Permit #: ZON11-00003
Project Name: A G Bell Elementary School PUD
Date: January 18th 2011

File: ZON11-00003 – AG BELL PUD AND MASTER PLAN

To: Jon Regala, Senior Planner
From: Deb Powers, Urban Forester
Date: May 26, 2011
Subject: Urban Forester Review ZON11-00003

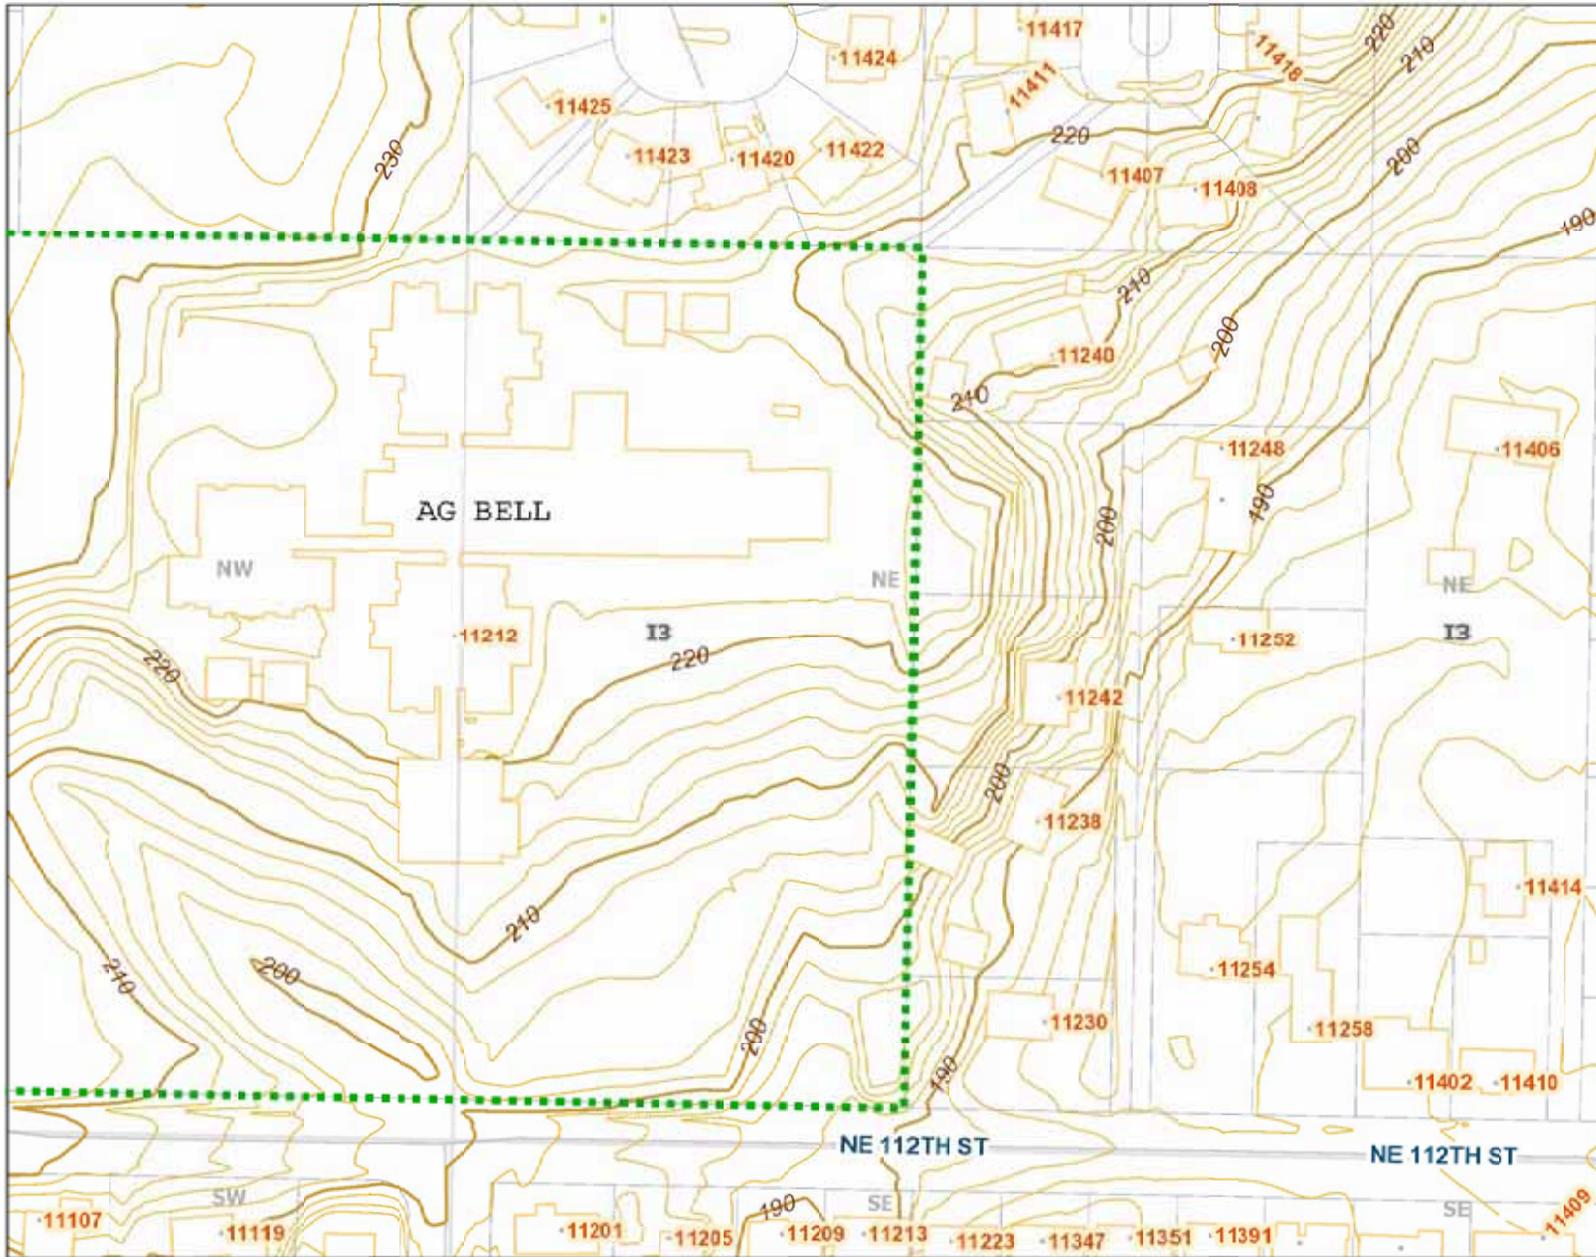
The applicant's Tree Retention Plan has been approved; all corrections have been addressed in the revision submitted May 10, 2011. The applicant should be commended for submitting a thorough Tree Retention Plan that exceeds the requirements of the City's tree retention codes, including an extensive tree inventory, the removal of hazard trees, creation of wildlife snags, and the retention of 'Memorial Trees'. For school projects, the City only requires the retention of trees that are located within required landscape areas, setbacks and buffers; many more trees on this site are shown to be protected.

Where improvements are shown within the limits of disturbance of retained trees, the applicant's arborist shall be on site for root pruning/monitoring to reduce impacts from construction. Sheet L8.0 has been redlined with this note; no revisions are required. This is particularly important for trees on the southern perimeter when frontage improvements are installed adjacent to Trees #1-2, and along the north perimeter for the installation of a fence, temporary fire lane and future bus drive (potentially impacting Trees #299-333). The existing trees along the north perimeter form a required landscape buffer; if it's determined that they cannot be retained or if they must be pruned or altered so that the trees no longer function as screening, additional required landscaping may be required here. If it is determined that installation of the required solid wood fence necessitates extensive pruning or tree removal, the City may allow chain link fence with privacy slats, pending approval by the Planning Official.
